ATTACHMENT 5

Letter from M. E. Warner (NMC)

License Amendment Request 187

Revised Pages for Updated Safety Analysis Report
(USAR)

Figure 14.1.4-3

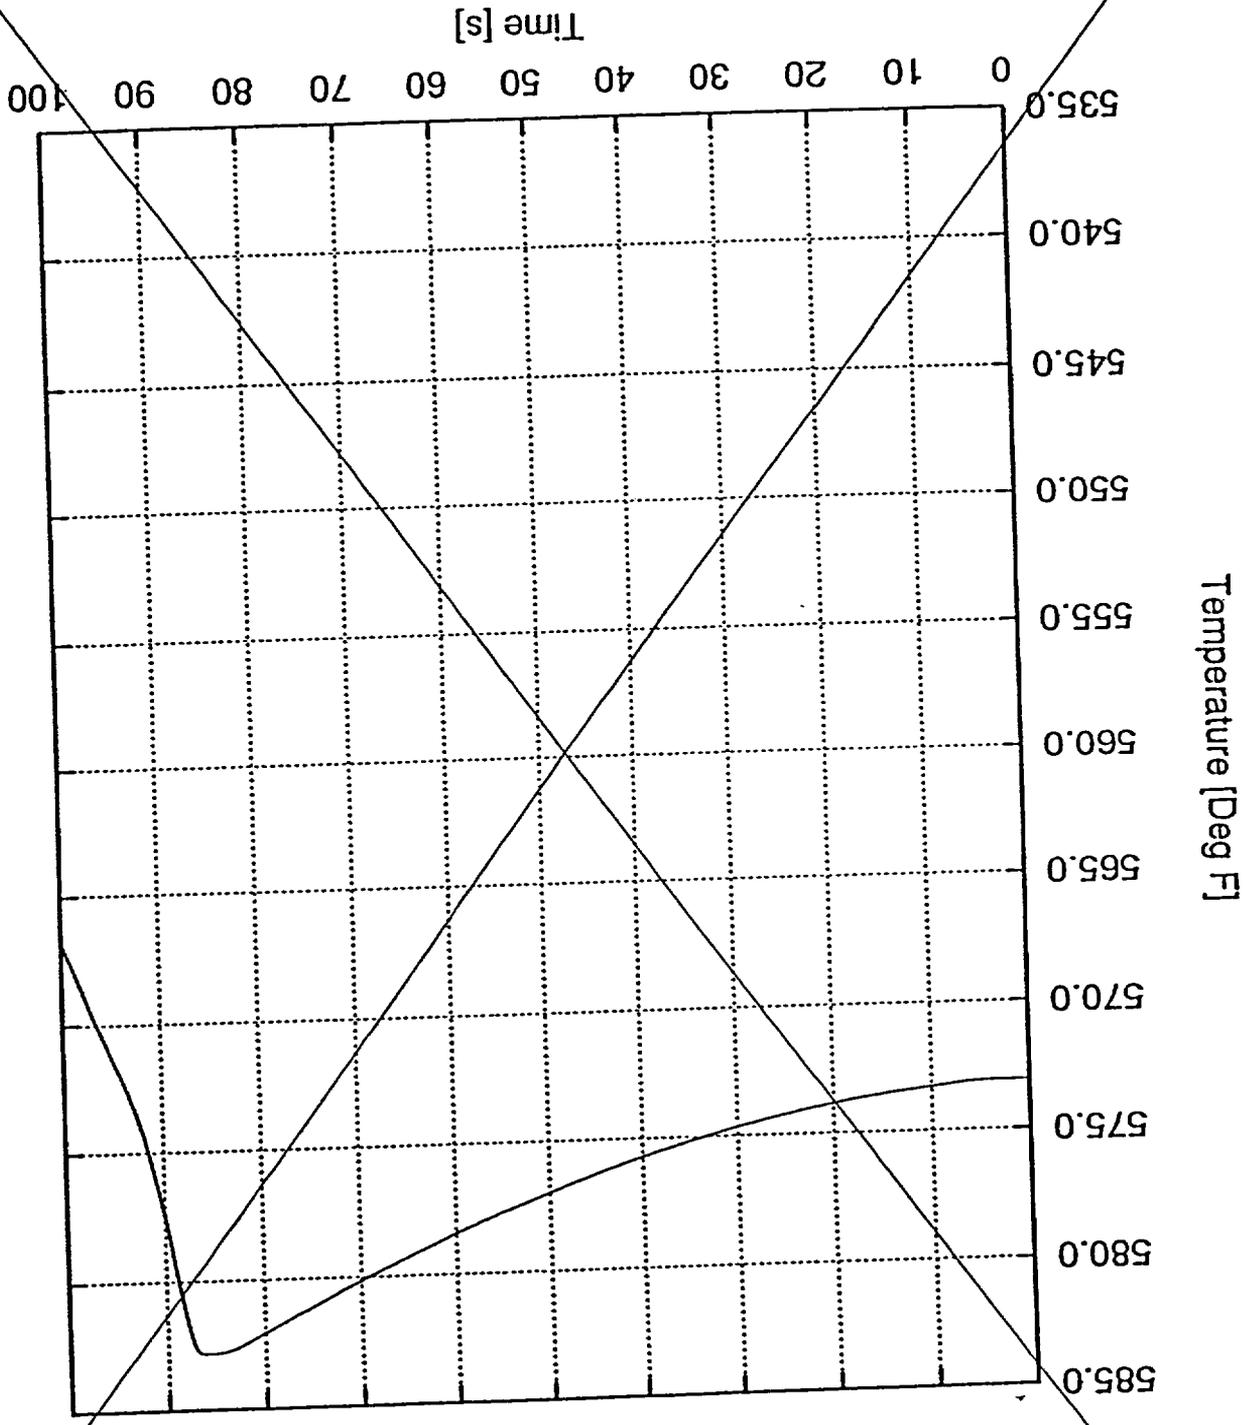
DELETED

Figure 14.1.4-5

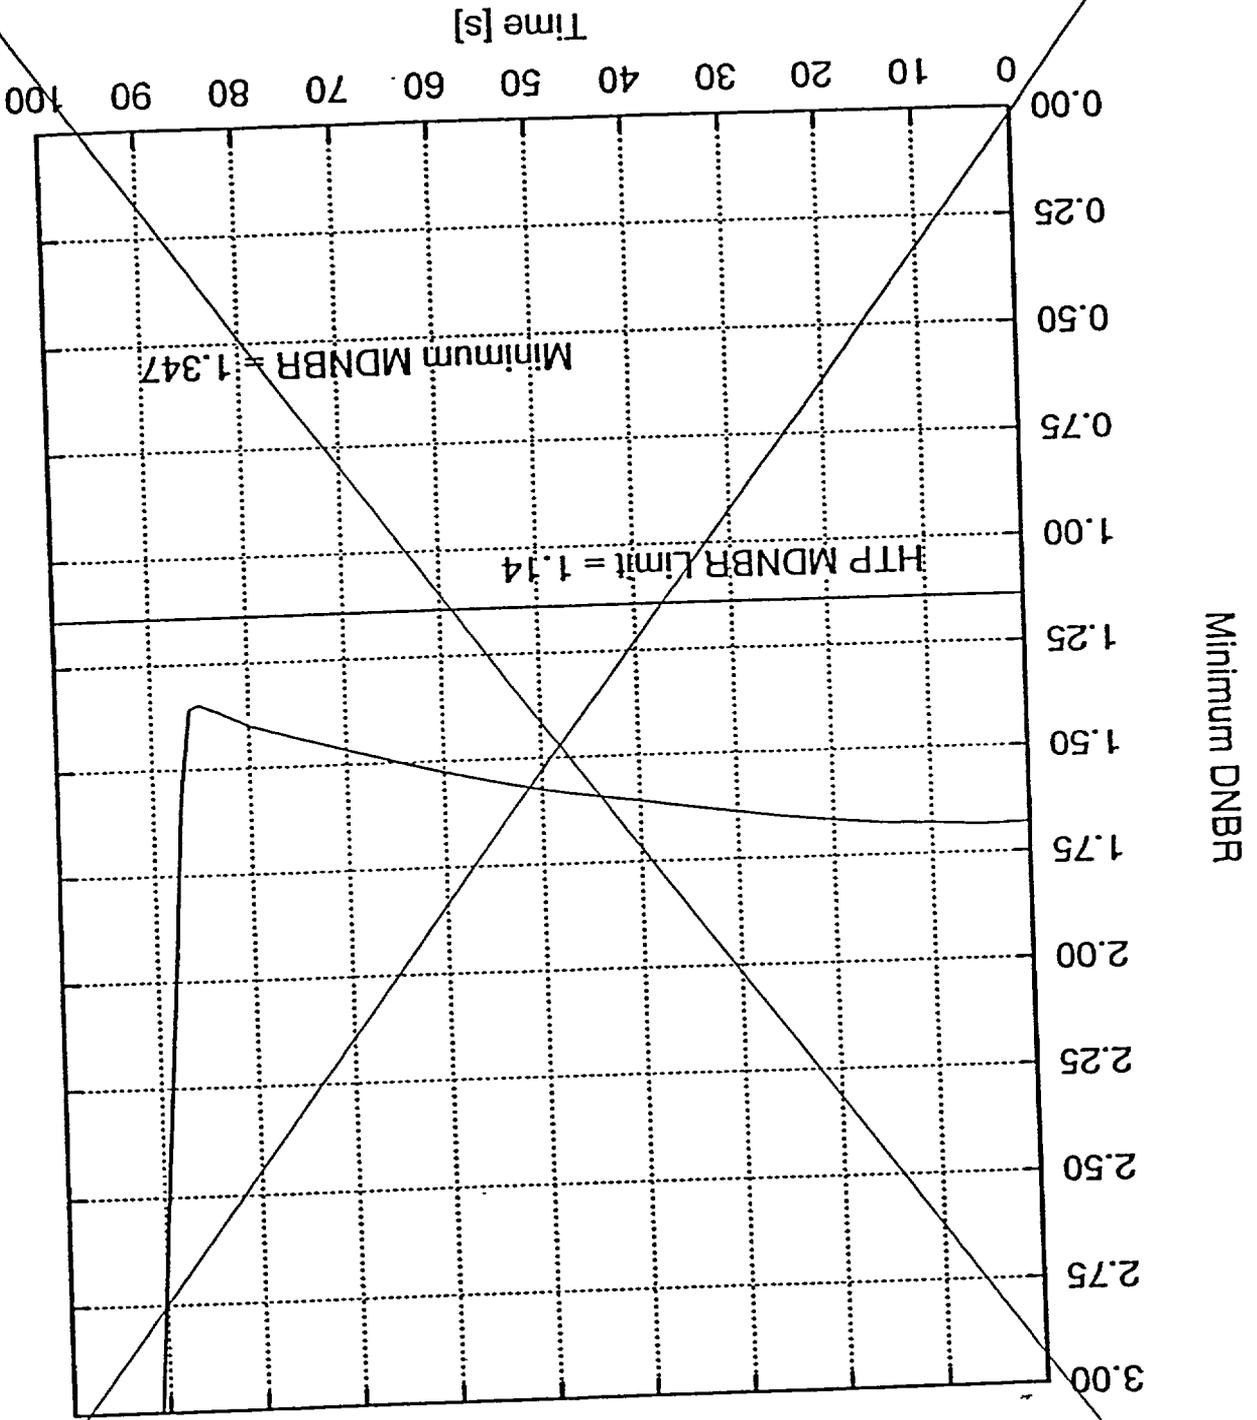
DELETED

Figure 14.1.6-1

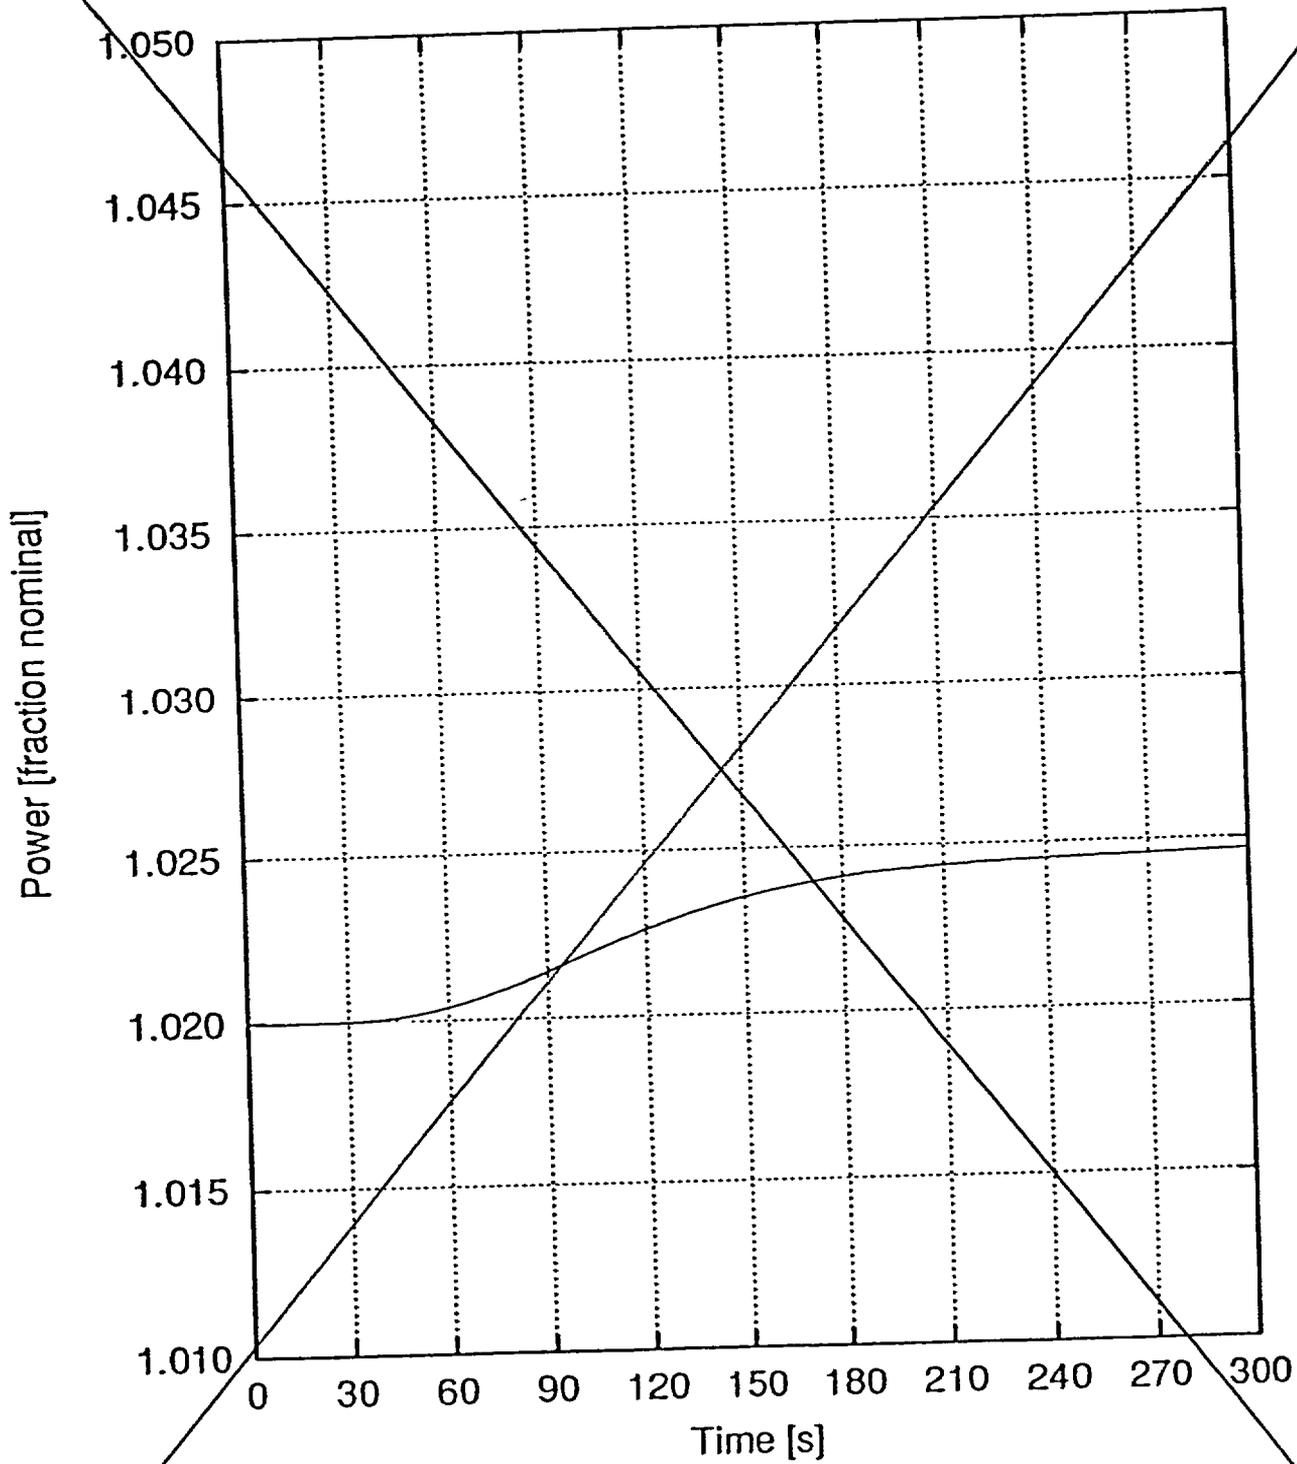
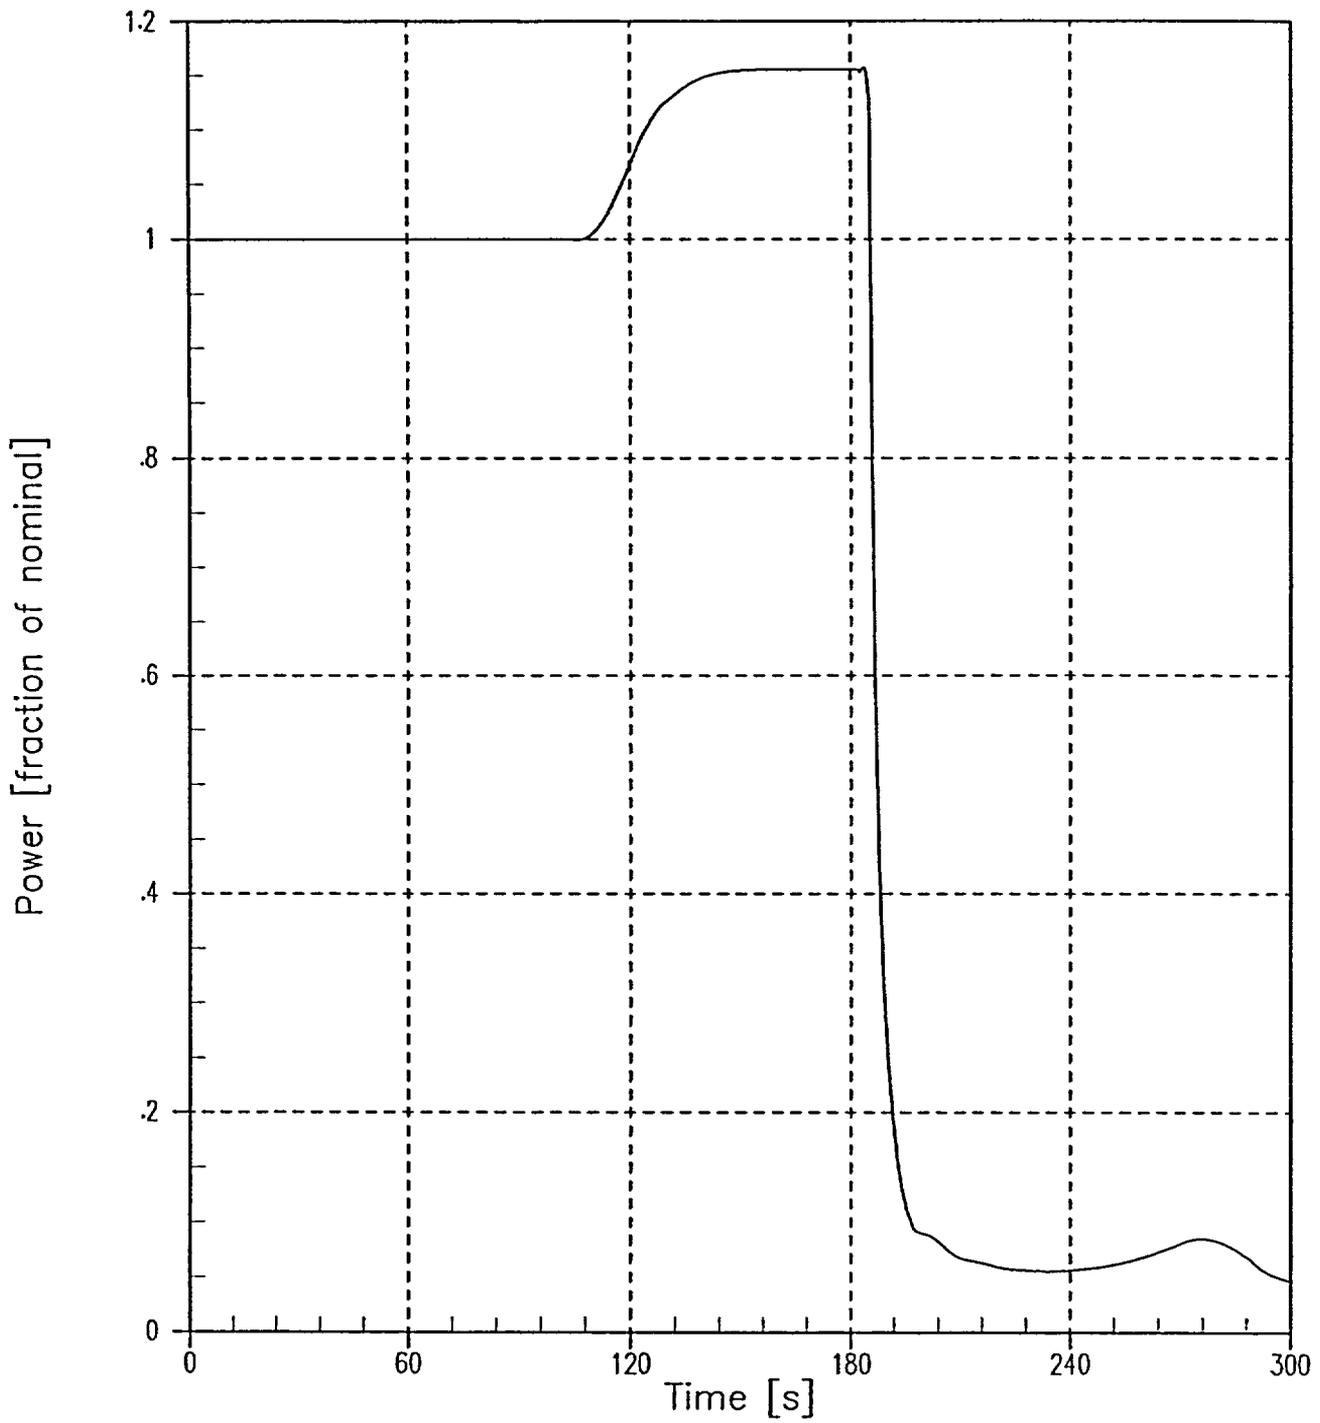
REPLACE WITH FIGURE 14.1.6-1 (ON FOLLOWING PAGE)

Figure 14.1.6-2

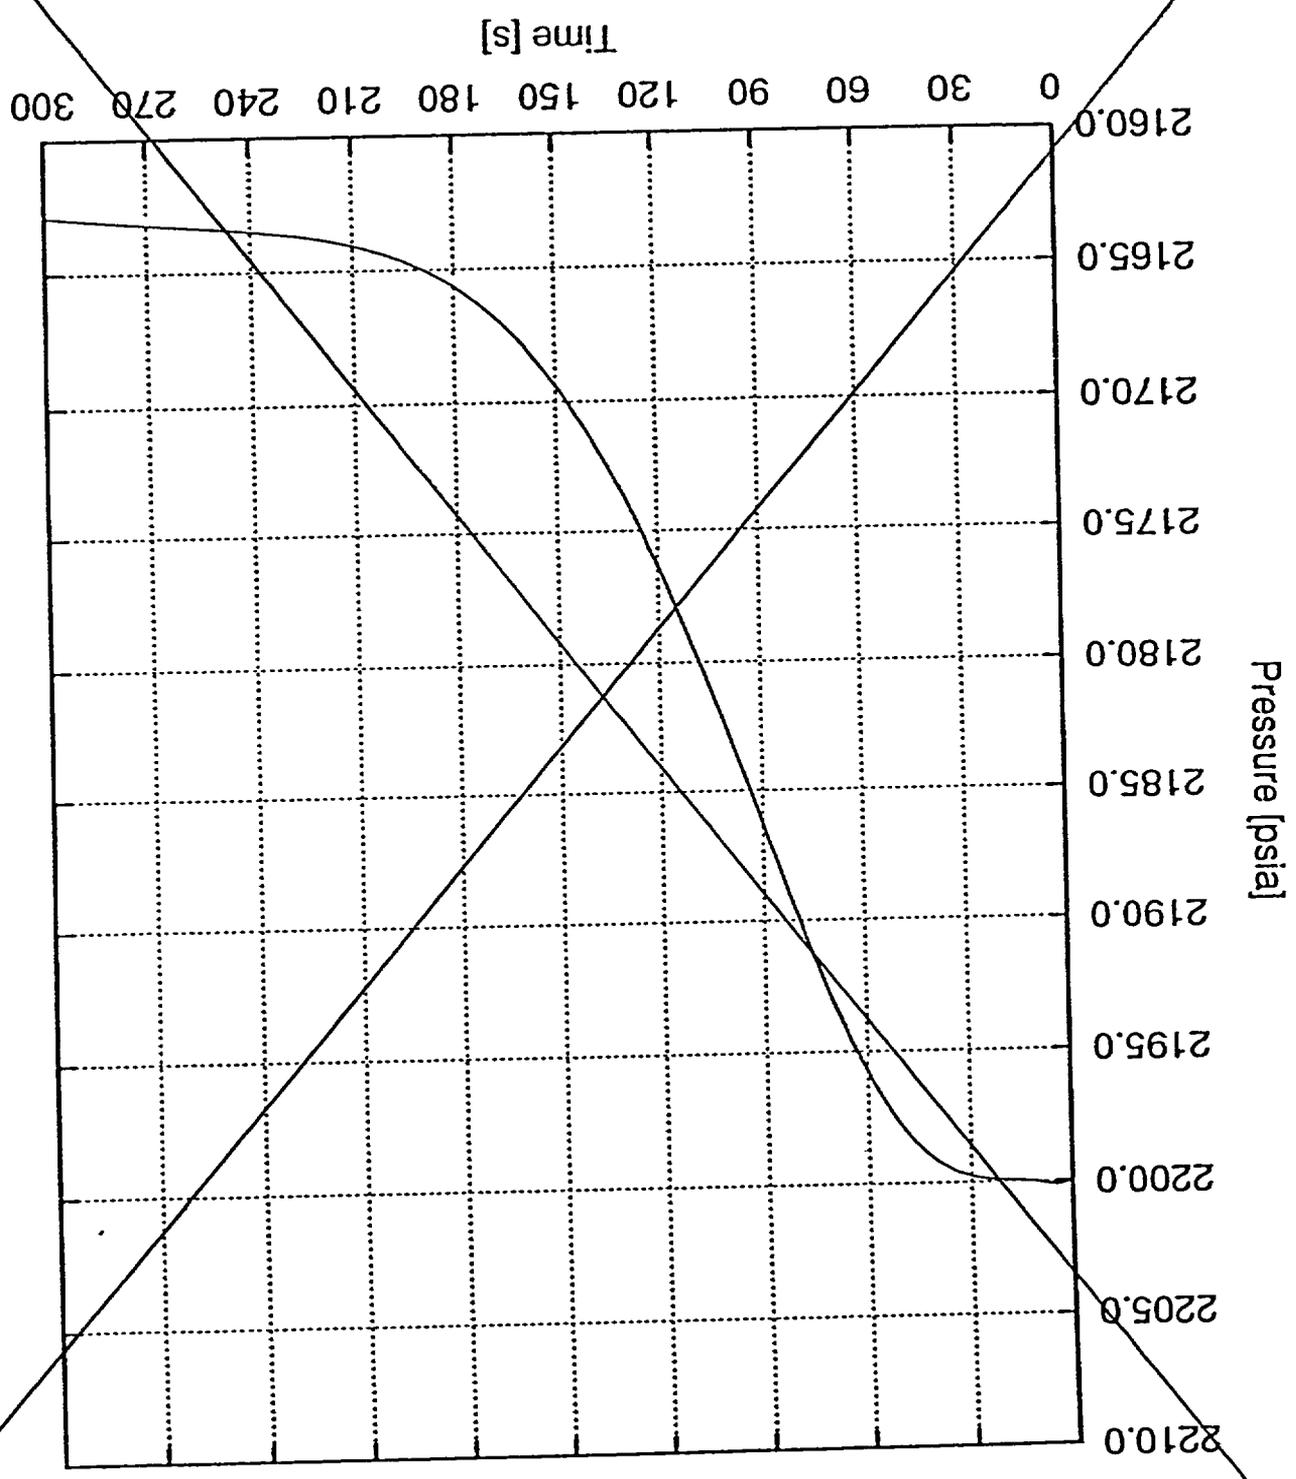
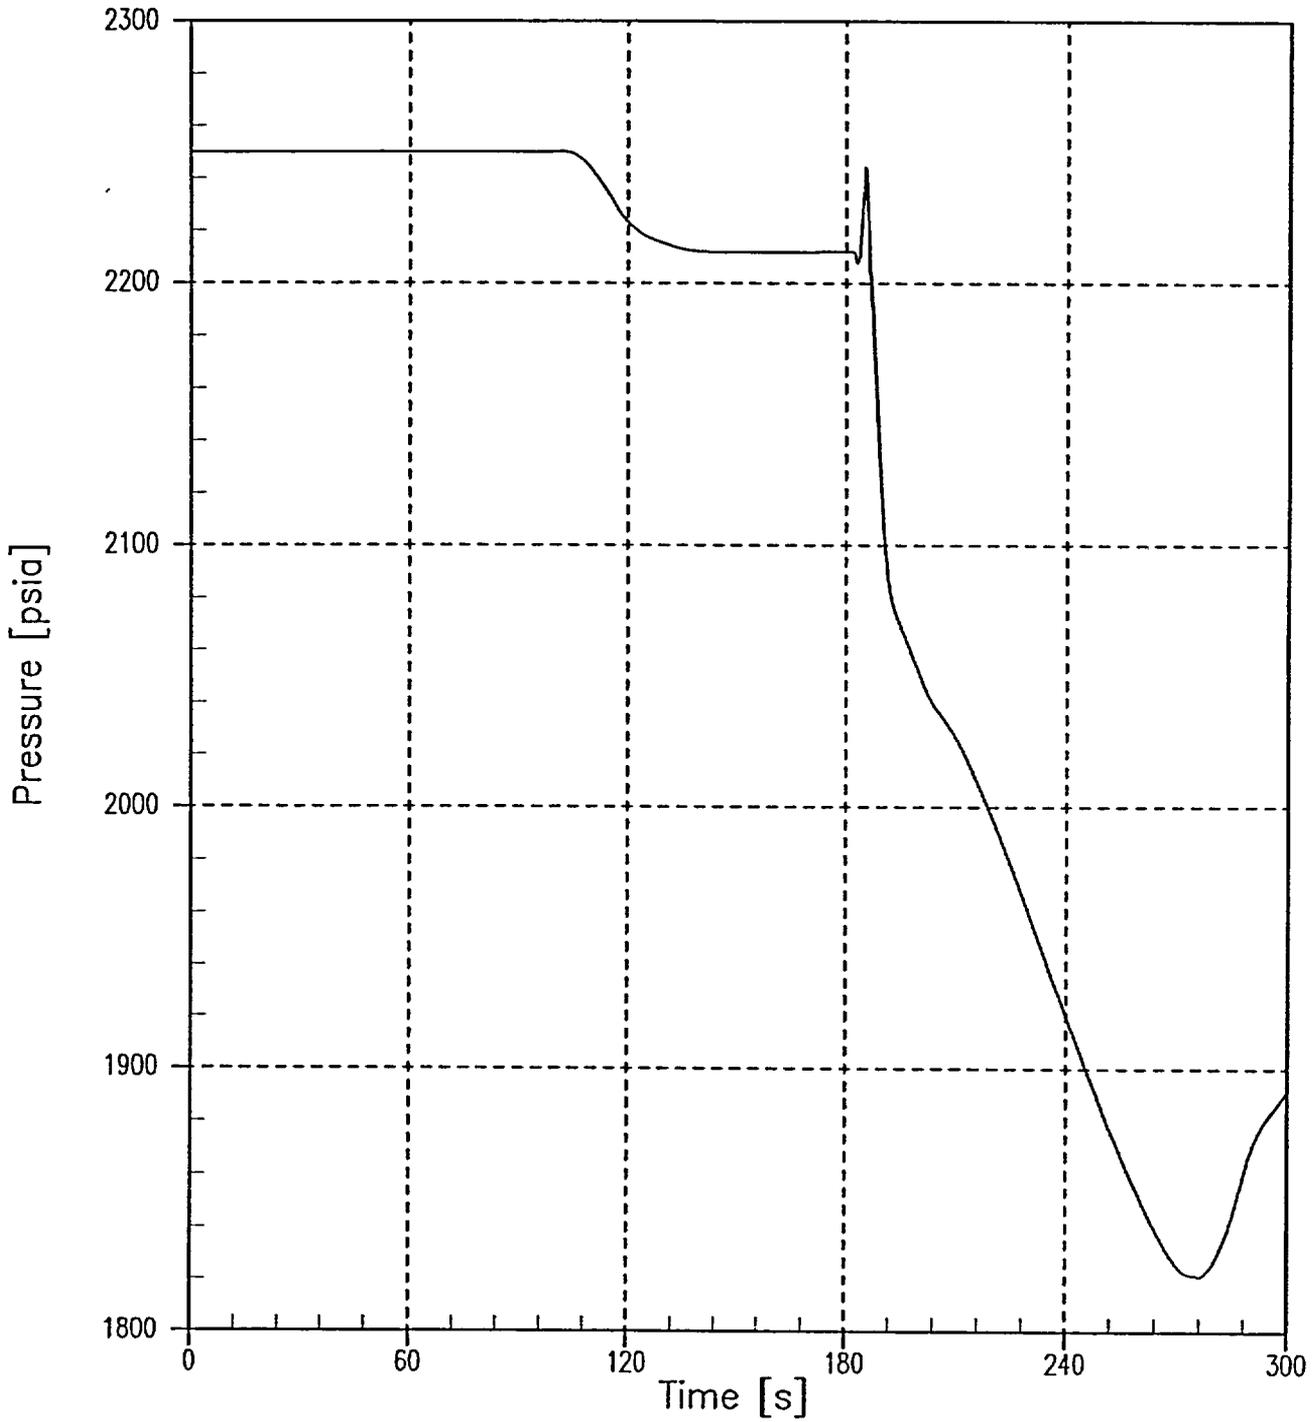
REPLACE WITH FIGURE 14.1.6-2 (on Following Page)
